Appendix A Brickwork Details | Core

2022 Consented Scheme

2022 Proposed S73

Appendix BFifth Floor Plan

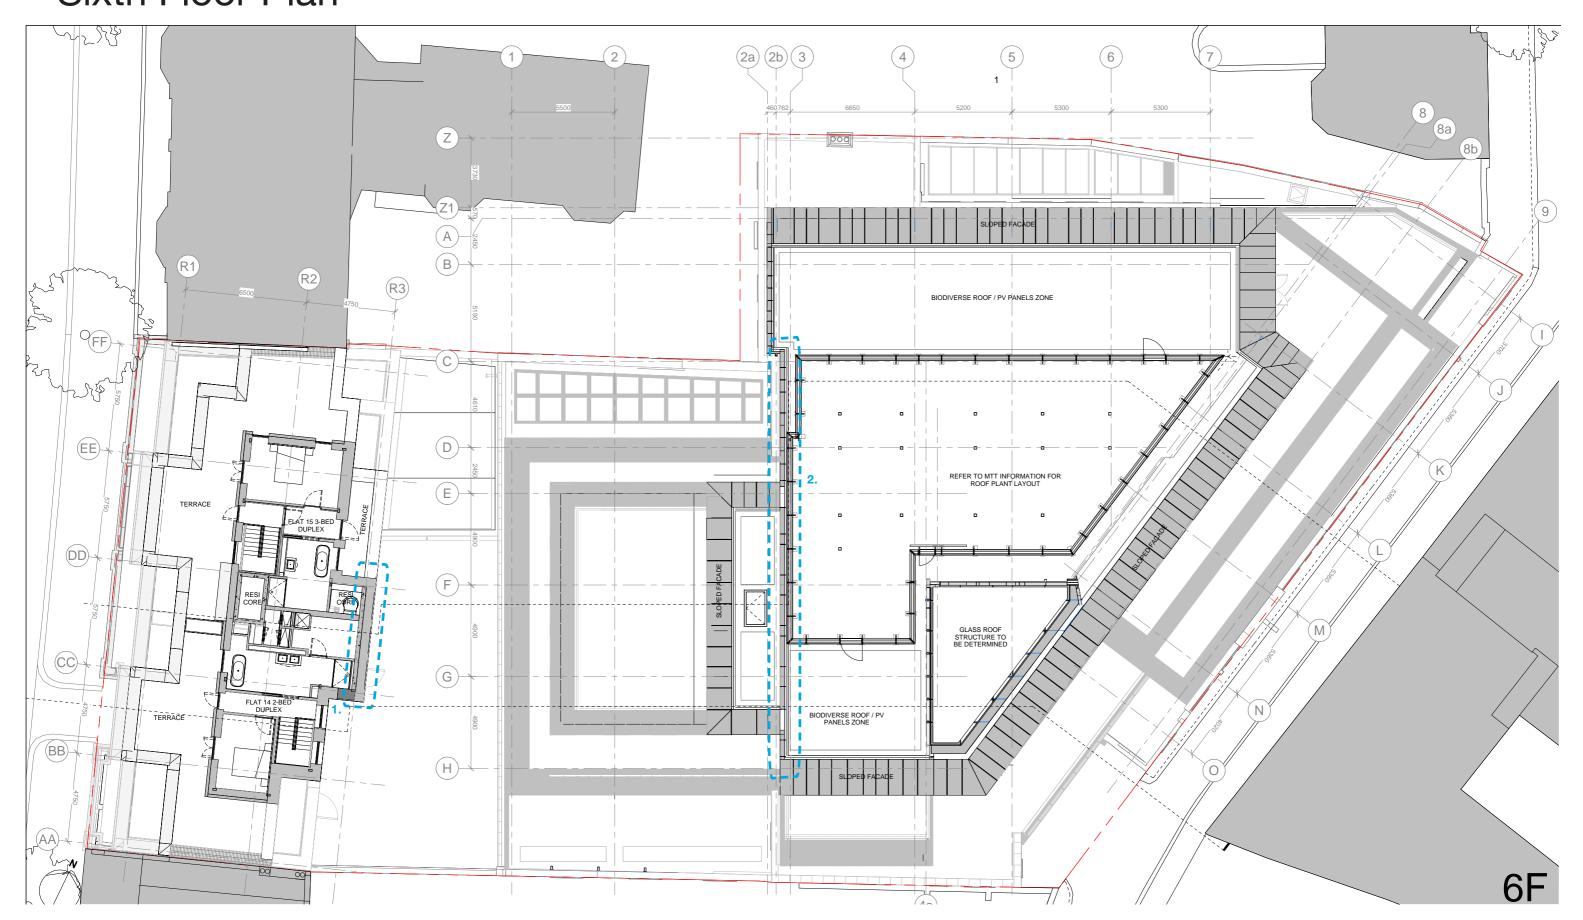
^{1.} External wall to rear expanded 50mm as per Appendix A to allow for greater insulation zone.

^{3.} Extension set in from existing facade to allow for better coping detail to level below.

^{2.} Enhanced party wall build-up to meet updated guidance

Appendix BSixth Floor Plan

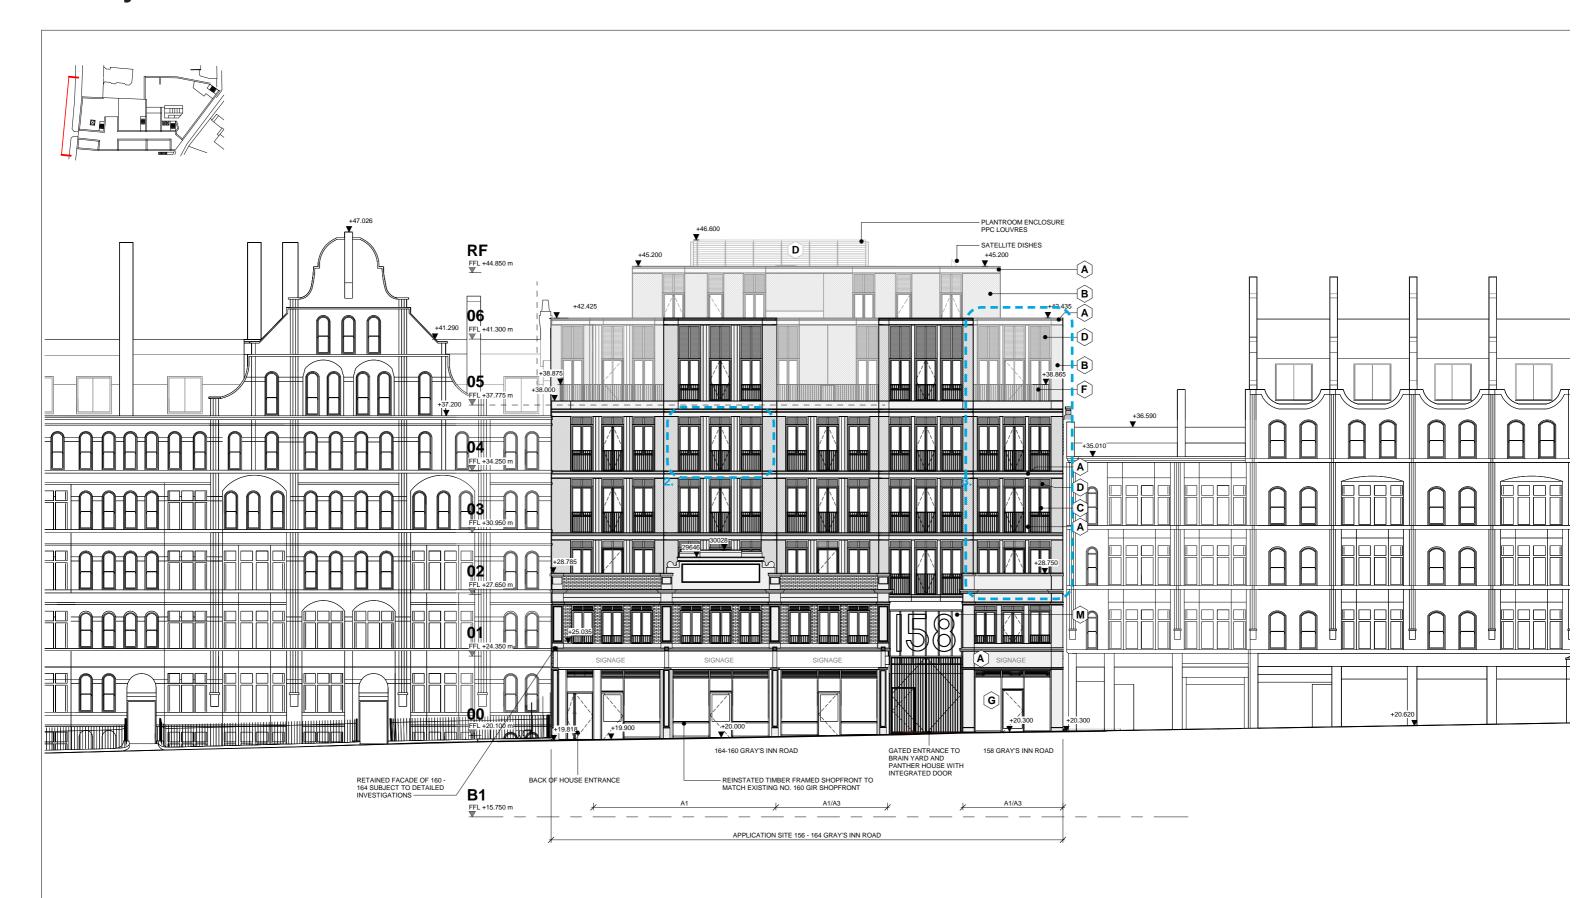
^{1.} External wall to rear expanded 50mm as per Appendix A to allow for greater insulation zone.

^{2.} Roof line set in to align with set back below

Gray's Inn Road West Elevation

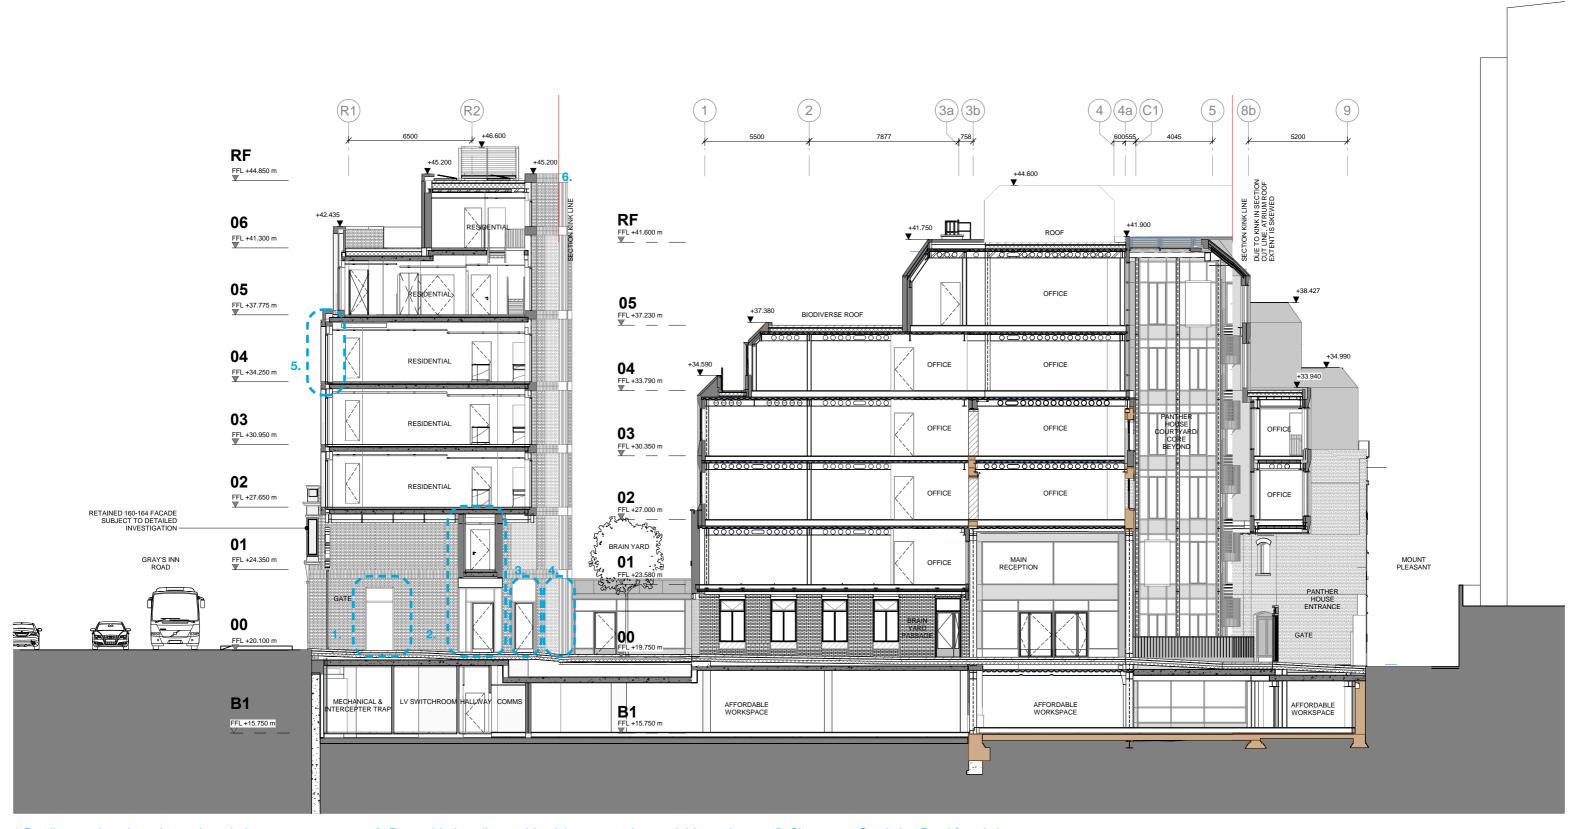
Retail secondary door changed to window
 Bridge widened and alignment to residential entrance door below honoured.

^{3.} Door added to allow residential escape to bypass lobby and allow for direct egress to external areas4. Secondary gate omitted

^{5.} Changes to Gray's Inn Road facade bay

^{6.} Wall Build-ups increased 50mm to meet Part L regulations
